Re: Roadrunner Veterinary Hospital
5971 Jefferson St. NE
Traffic Circulation Layout
Architect's Stamp 08-16-23 (E17-D078)

Based upon the information provided in your submittal received 09-26-23, the above referenced plan cannot be approved for Building Permit until the following comments are addressed:

G4 ADA PARKING SIGNAGE

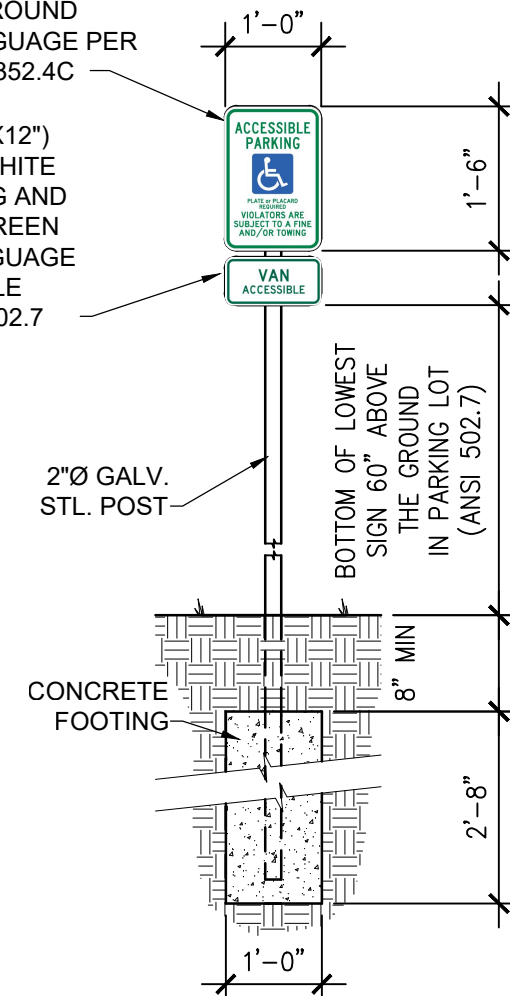
7. The ADA accessible spaces must include an access aisle. Van accessible aisles should be 8ft wide; all others should be 5ft wide.
8. **All ADA signage** must be updated to the current standard. The ADA accessible parking sign must have the required language per 66-7-352.4C NMSA 1978 "**Violators Are Subject to a Fine and/or Towing.**" Please call out detail and location of signs.
9. **All the ADA access aisles** shall have the words "**NO PARKING**" in capital letters, each of which shall be at least one foot high and at least two inches wide, placed at the rear of the parking space so as to be close to where an adjacent vehicle's rear tire would be placed. (66-1-4.1. B NMSA 1978)

B3 TRAFFIC CIRCULATION LAYOUT
1" = 20'-0"

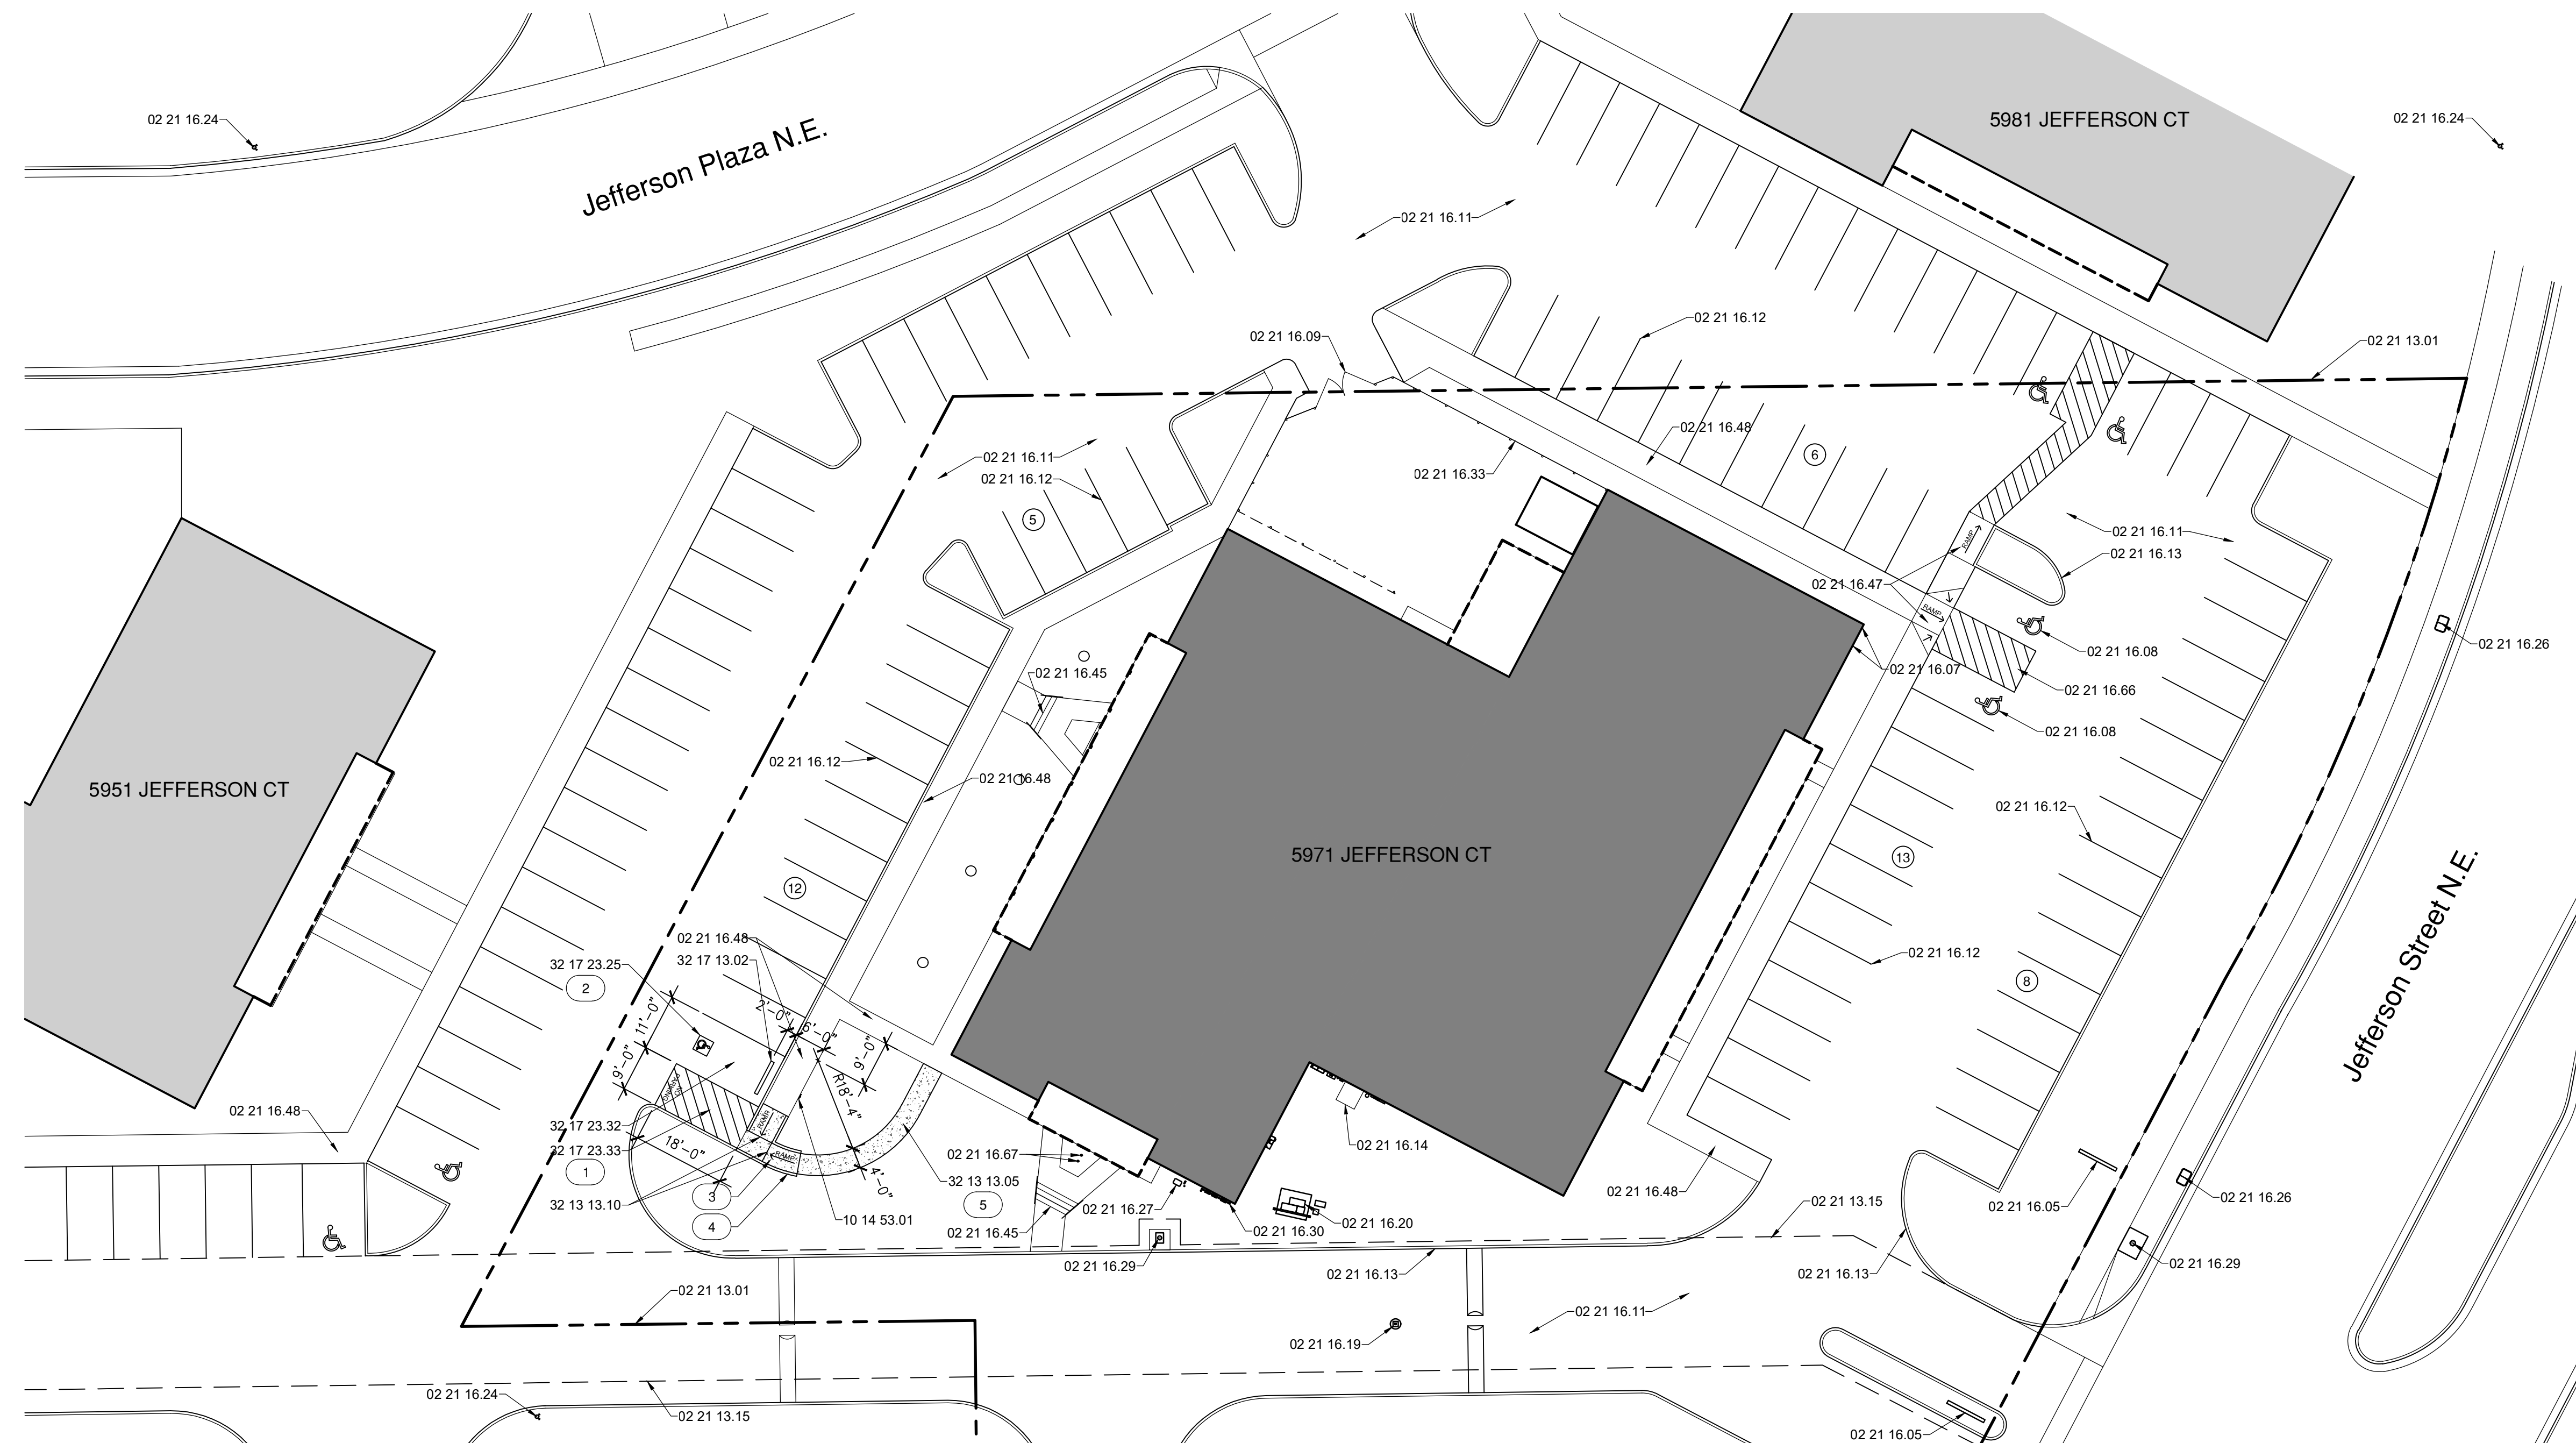
1. List the number of Motorcycle and Bicycle parking spaces required by the IDO.
2. Identify all existing access easements and rights of way width dimensions.
3. Show on the site plan the existing site accesses width.
4. Due to show the property line in the middle of the site, please provide approved plat showing shares accesses and parking agreement.
5. Please list the width and length for all existing and proposed parking spaces. Some dimensions are not shown.
6. The minimum parking stall dimensions are:

10. ADA curb ramps at the site accesses must be updated to current standards and have truncated domes installed.
11. All the interior existing ADA curb ramps must be updated to current standards and have truncated domes installed.

12. Motorcycle parking spaces shall be designated by its own conspicuously posted upright sign, either free-standing or wall mounted per the zoning code.

13. The pavement marking "MC" should be shown in the opposite direction for motorcycles entering the parking space.
14. All bicycle racks shall be designed according to the following guidelines:

18. Show all drive aisle widths and radii. Some dimensions are not shown.
19. The minimum drive aisle dimensions are shown below

20. Per the IDO, a 6 ft. wide ADA accessible pedestrian pathway is required from the public sidewalk to the building entrances. Please clearly show this pathway and provide details.
21. Per DPM, a 6 ft. wide ADA accessible pedestrian pathway is required from the ADA parking stall access aisles to the building entrances. Please clearly show this pathway and provide details.
22. ADA accessible pedestrian pathway should not be placed behind parking space or adjacent to a vehicular way. Vehicle and pedestrian/wheel chair conflicts should be avoided as much as possible.

23. Provide a copy of Fire Marshal and Solid Waste approval.
24. It is not apparent what type of pavement surface is being proposed. A hard driving surface will be required as part of this proposed project for parking area and drive aisles.

25. Show the Intersection clear sight triangle and add the following note to the plan:
"Landscaping and signage will not interfere with clear sight requirements. Therefore, signs, walls, trees, and shrubbery between 3 and 8 feet tall (as measured from the gutter pan) will not be acceptable in the clear sight triangle.

26. Please specify the City Standard Drawing Number when applicable.
27. Add a note stating "All broken or cracked sidewalk must be replaced with sidewalk and curb & gutter." A build note must be provided referring to the appropriate City Standard drawing.
